I am **not** opposed to this project. I recognise the benefits that can come from this project and the flow-on benefits for the community. I only seek to have reasonable and transparent consent conditions that will protect us as near neighbours, protect the wider community and the environment from adverse impacts.

SYERSTON PROJECT MODIFICATION 4

FIGURE A4-7
 Predicted Maximum Ground Level Concentrations of SO₂

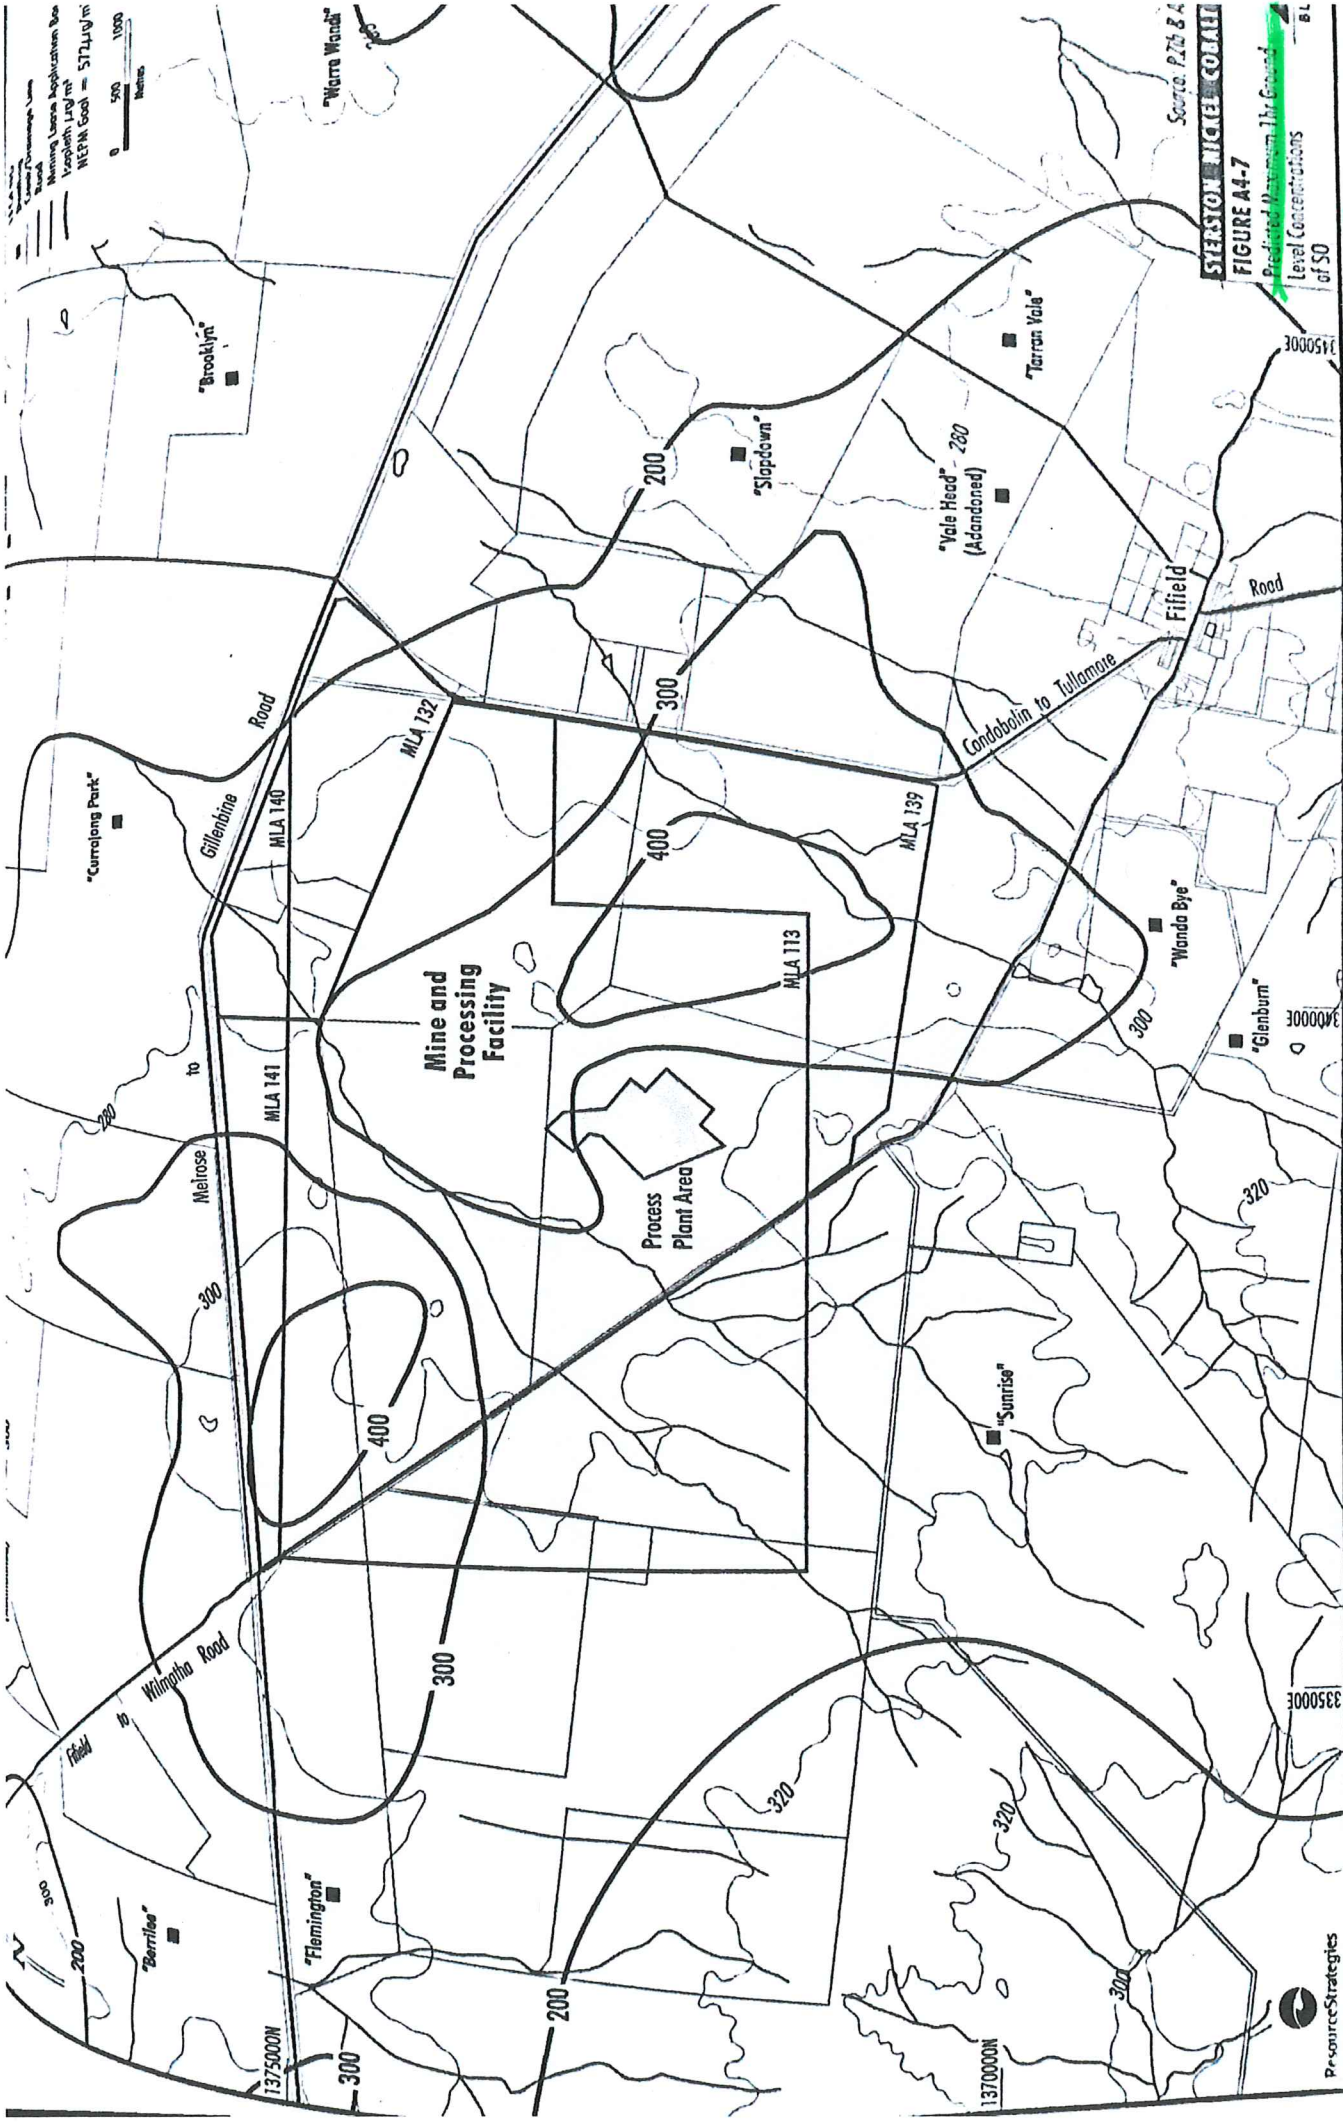
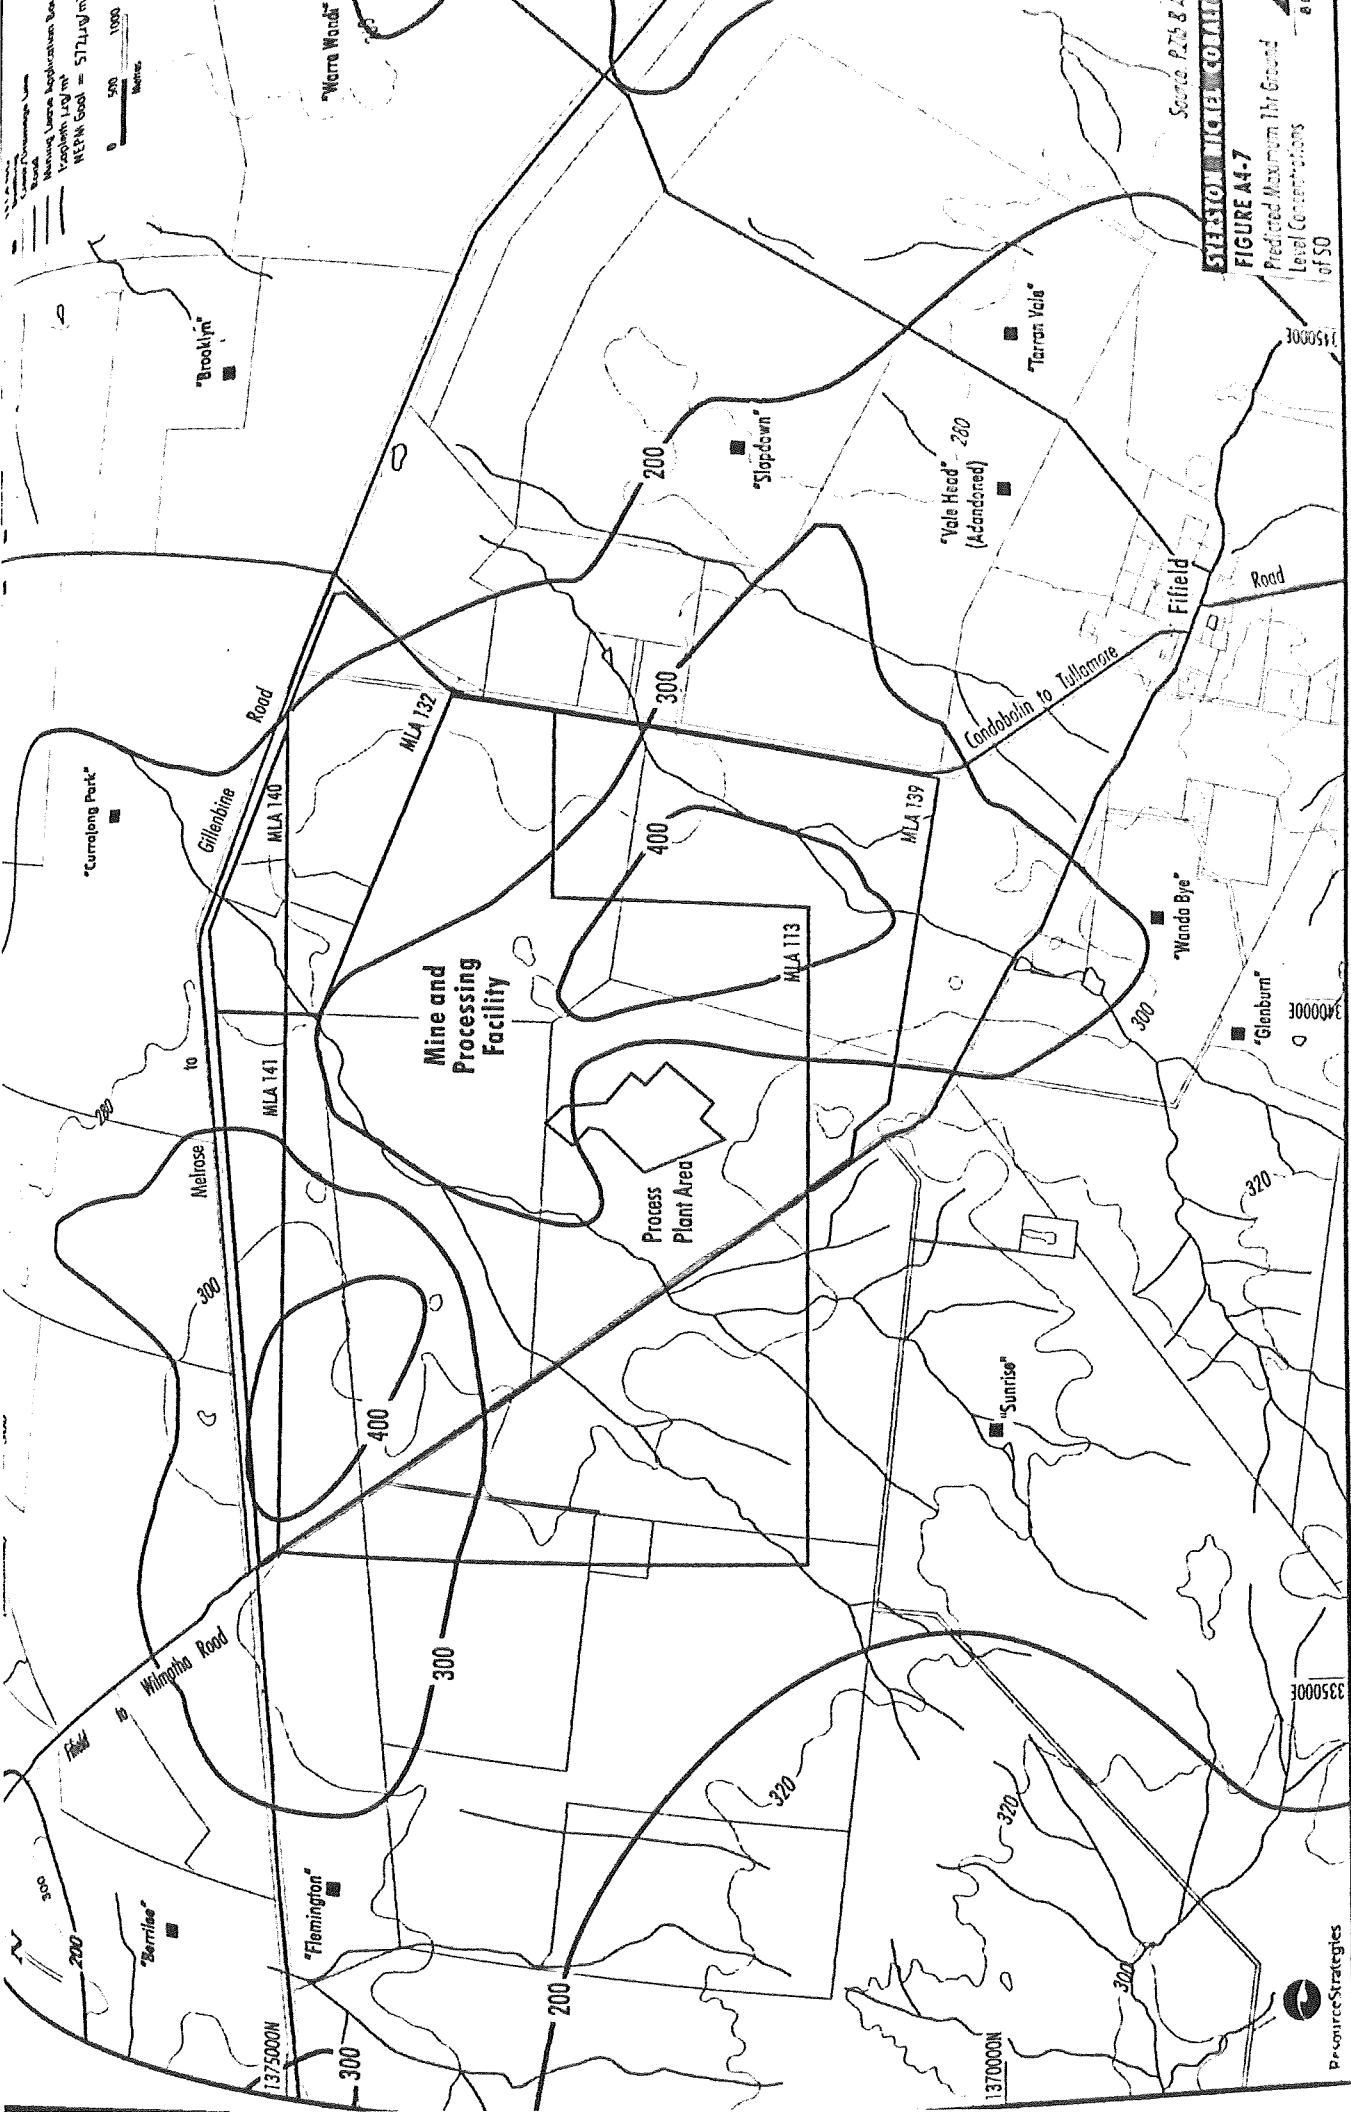
An increase in sulphuric acid of (700,000 to 1,050,000 tonnes /annum) a 50% increase, will be required and therefore more sulphur dioxide will be emitted from the 80 metre high stack. The response to this question in the Mod 4 submission was that "overall there would be less emissions". That answer to me, raises more questions that it answers.

The atmospheric data used by CLQ in its modelling, was from the weather station at Condobolin using data from one year 2015. I have travelled to Condobolin, from my property Berrilee, for 46 years, and can assure you that the weather at Condobolin and the project site can vary enormously.

A weather station on site would give a more accurate picture of the conditions. Maybe then, the modelling maps of emissions from the original DA, and this MOD4, might look a bit more alike. I do not have any confidence in the modelling presented by the company for noise, dust or emissions.
